**Total E&P Canada Ltd.  
Surface Steam Release of May 18, 2006  
Joslyn Creek SAGD Thermal Operation**

**ERCB Staff Review and Analysis**

**February 11, 2010**

**ENERGY RESOURCES CONSERVATION BOARD**

Figure 6. Total's 3-D seismic interpretation of dilation chimneys

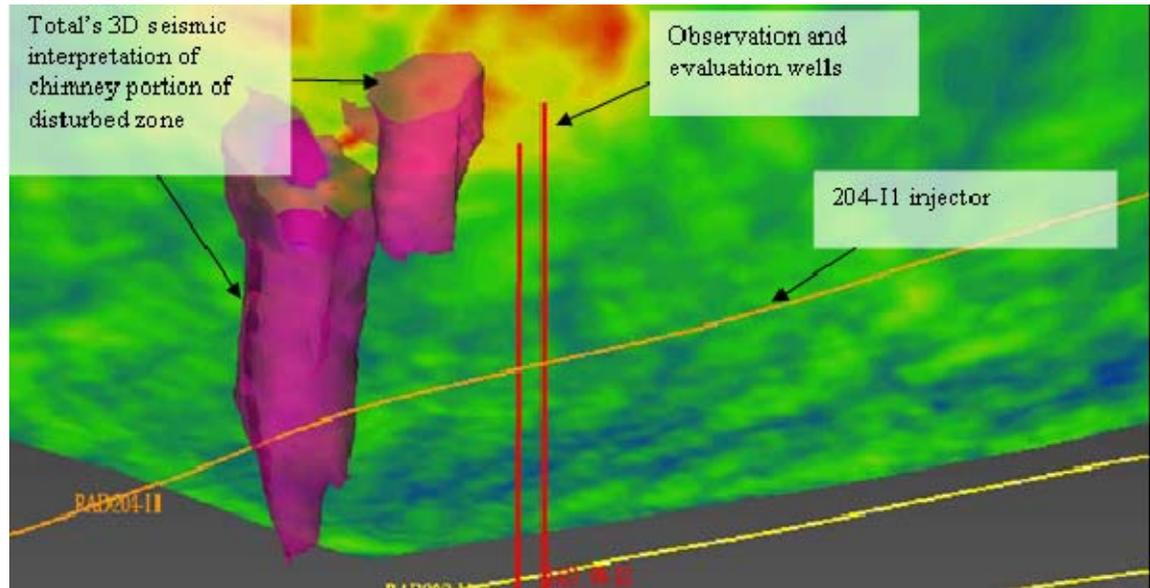
Staff agrees that Total's 3-D seismic interpretation would appear to show that both the 00/9-33 and AB/9-33 vertical wells were not within the narrow disturbed zone that extended down to injector 204-I1.

Staff notes that this scenario does not require the existence of a dilation chimney, but could still match other aspects of Total's release scenario. The main weakness of this scenario is that Total's 3-D seismic interpretation showed that these wells slightly offset the vertical chimney interpreted for the steam release pathway. Staff is concerned that the seismic may have been affected by the much larger disturbed area above the narrow chimney, reducing the accuracy of the response for determining the exact chimney location relative to the vertical wells.

Figure 9. Vertical wells overlaid on a photograph of release site from Total's final report

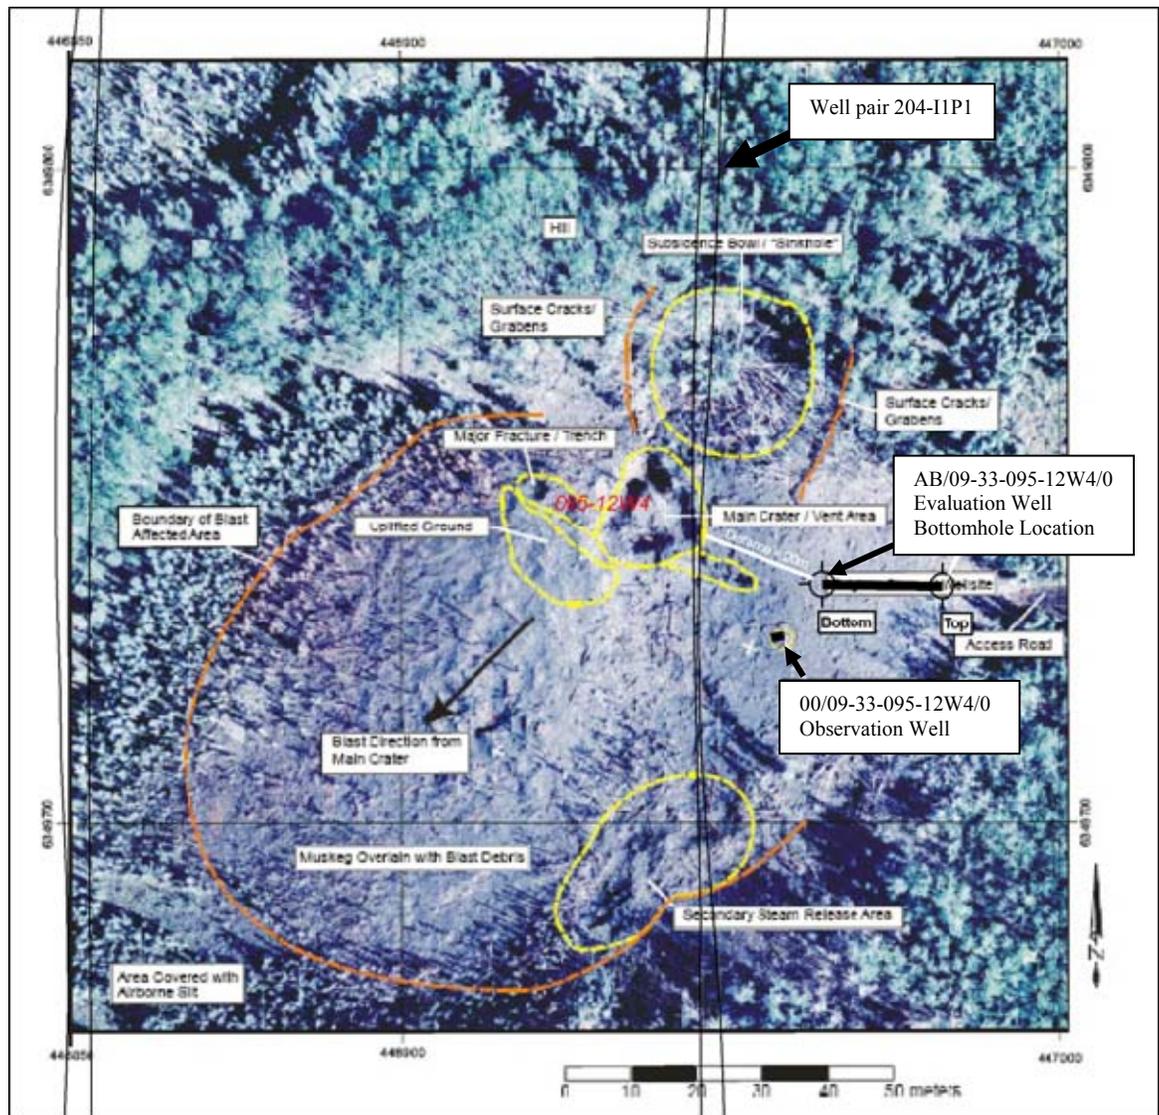
Staff considers it to be a significant coincidence that the steam release occurred in the same location as two vertical wells: observation well 00/9-33 and evaluation well AB/9-33. Figure 9 shows an aerial photograph of the the release site, with the location of the two vertical wells and well pair 204-I1P1 overlaid. It shows that the main steam release surface crater was within 20 m of the bottomhole location of evaluation well AB/9-33 and within about 30 m of observation well 00/9-33. Both wells are completely within the surface disturbed area caused by the steam release, and both are less than 20 m from the well pair 204-I1P1.

The abandoned evaluation well AB/9-33 was not cased and could not be located from surface.

Figure 10. Well pair 204-I1P1 pressures and steam injection rates

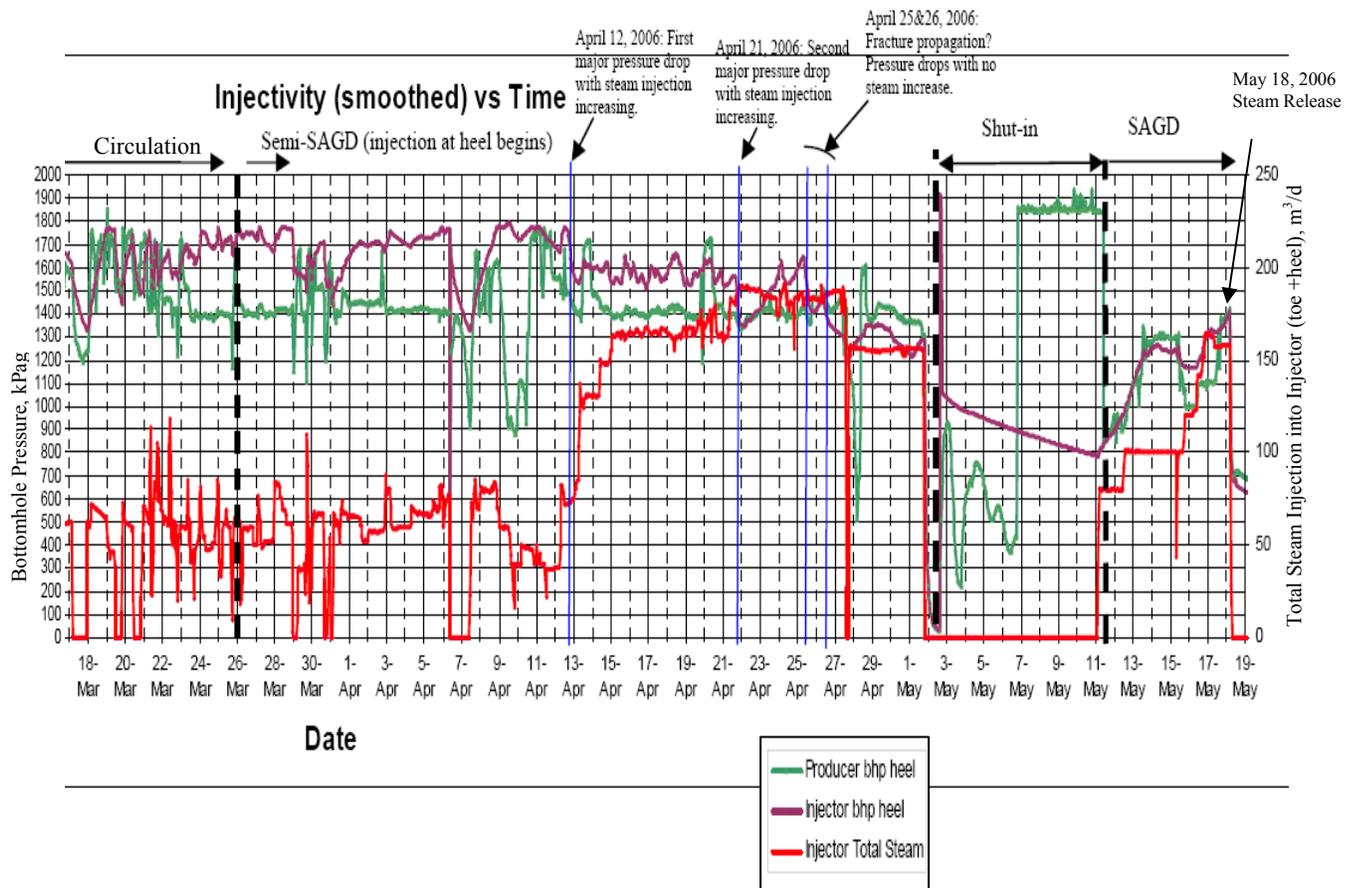
Similarly, Total did not provide modelling or analysis supporting its contention that the heat transfer to the reservoir would be greatest at the heel of the well during circulation, when steam was being injected to the toe of the well.

Total stated that during circulation the reservoir was heated mainly by conductive heat transfer. Steam was not expected to move into the reservoir (i.e., convective heat transfer), because the easiest pathway was back up the well. However, under semi-SAGD the returns on the injector 204-I1 were shut in. Steam continued to be injected at the toe through the long tubing, but the short tubing was converted to inject steam at the heel of the injector (the producer 204-P1 continued to circulate). The steam had nowhere to go but into the reservoir. Staff believes that it is likely no coincidence that the first fracturing event, identified from bh pressure and injection information, occurred 2½ weeks after well pair 204-I1P1 went on semi-SAGD (see Figure 10). The sudden introduction of steam to the heel of the injector likely also explains why the steam release occurred near the heel.

Figure 11. 3-D seismic mapping of localized sinkhole from the Husky Caribou application

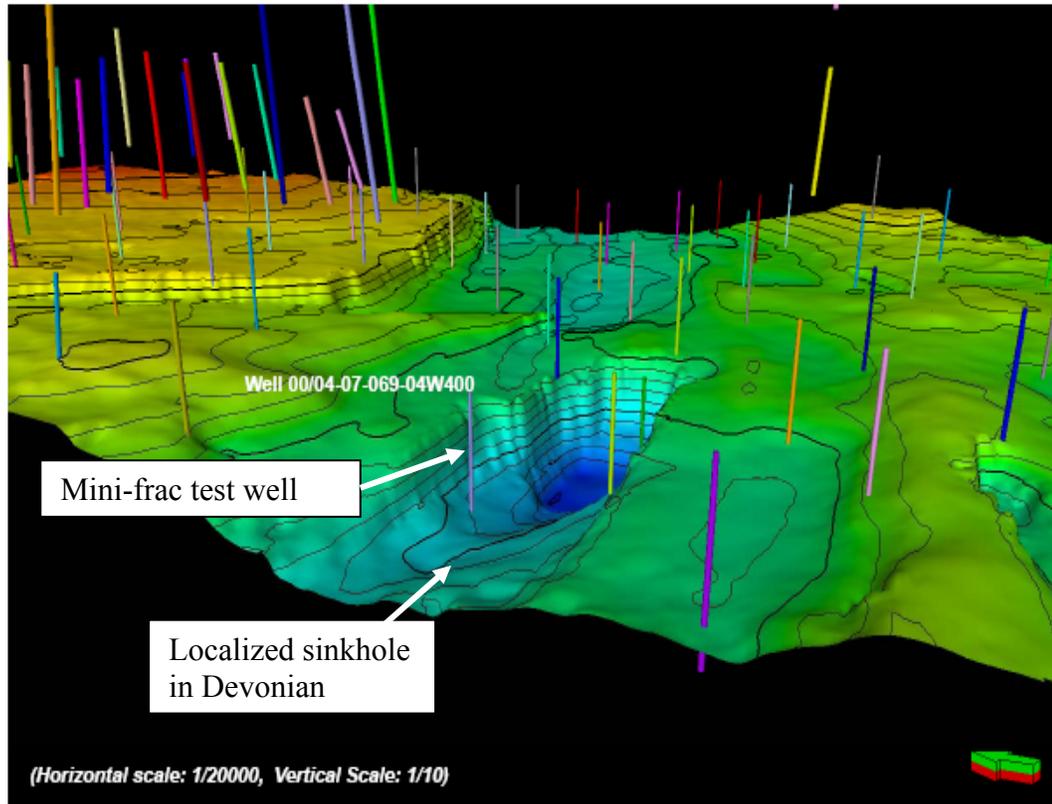
In support of this scenario, an example of a localized reduction in horizontal stress due to karsting was provided in Husky Oil Operations Limited's October 2008 submission on its proposed Caribou CSS scheme.<sup>3</sup> Husky provided the results of a mini-frac test on well AA/04-07-069-04W4. This well was drilled in a sinkhole area caused by karsting (see Figure 11), and the mini-frac results showed that the local fracture gradients were significantly below the vertical stress gradient of 21 kPa/m (they varied from 11.5 to 16.7 kPa/m).

Husky concluded that fractures would be vertical within the localized sinkhole area, but expected them to be horizontal elsewhere. Husky had planned to do further testing, but the application has since been withdrawn. Staff concludes that over distances of less than 1 km the fracture pressure could drop significantly and the fracture orientation could change from horizontal to vertical. Since karsting also results in the formation of natural fractures, staff believes that this scenario could occur in combination with the natural fracture pathway scenario.

AA/05-33-095-12W4

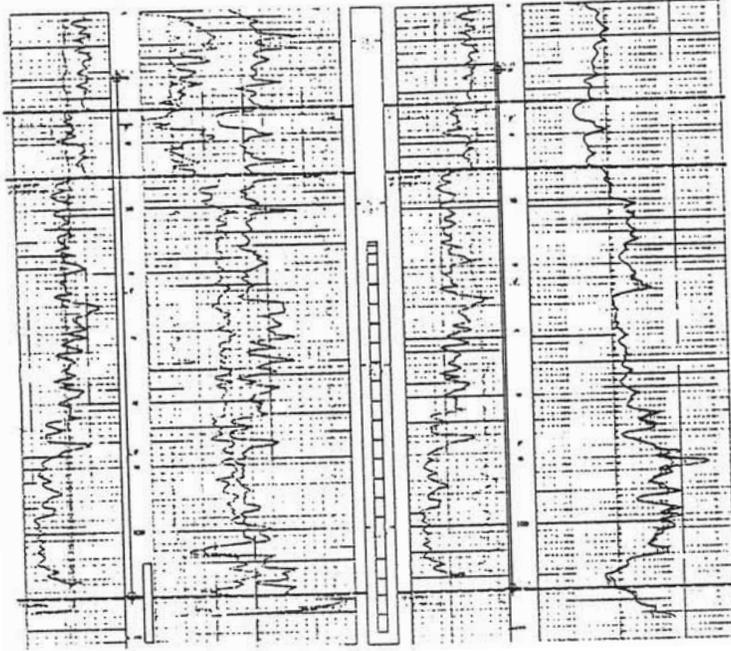
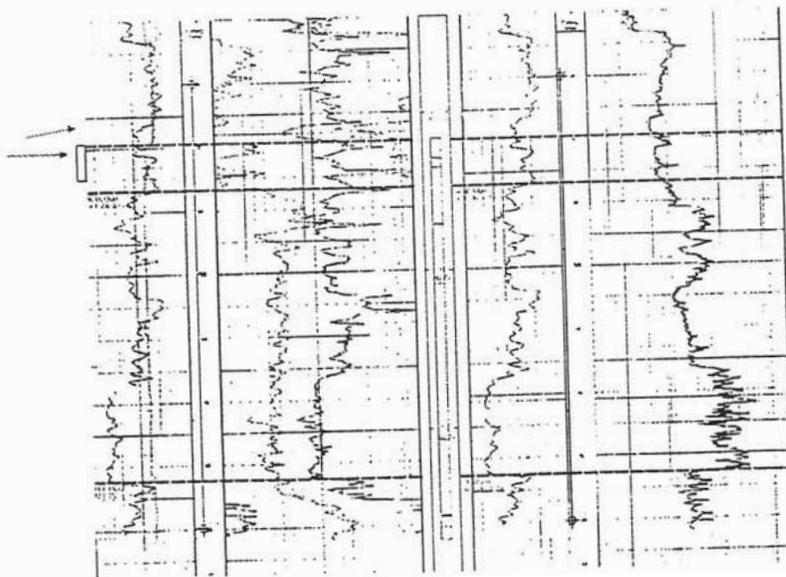
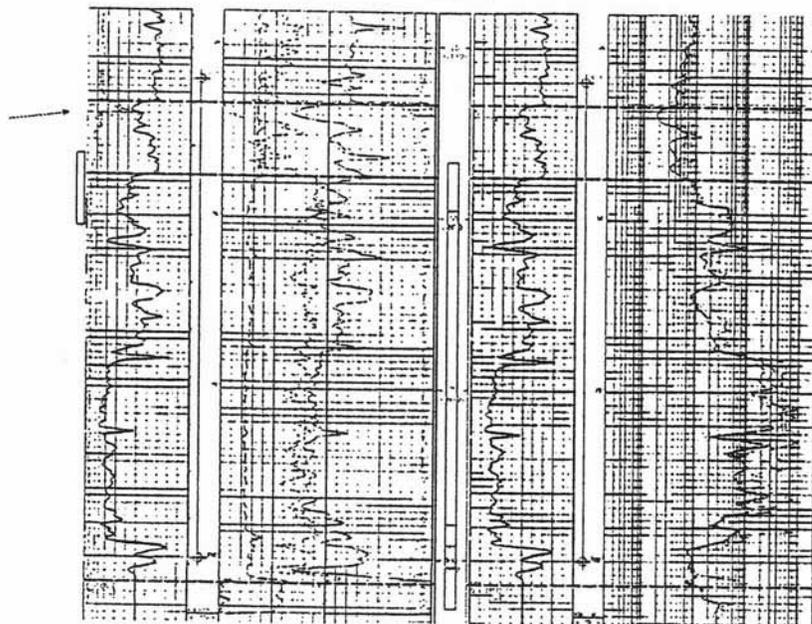
- In each of the following logs, there are marked in pink (magenta) one or two sands that occur just above and below the T21 marker, which is at the contact between the base of the Clearwater Formation and at the top of the Wabiskaw Member. Where there are two sands, separated by the T21 marker shale, the upper sand would be at the base of the Clearwater, and the lower sand would be the Wabiskaw A sand. Comment on the possibility of these sands being another potential upper thief zone at or near the top of the Clearwater, and the potential for a communication pathway to surface.
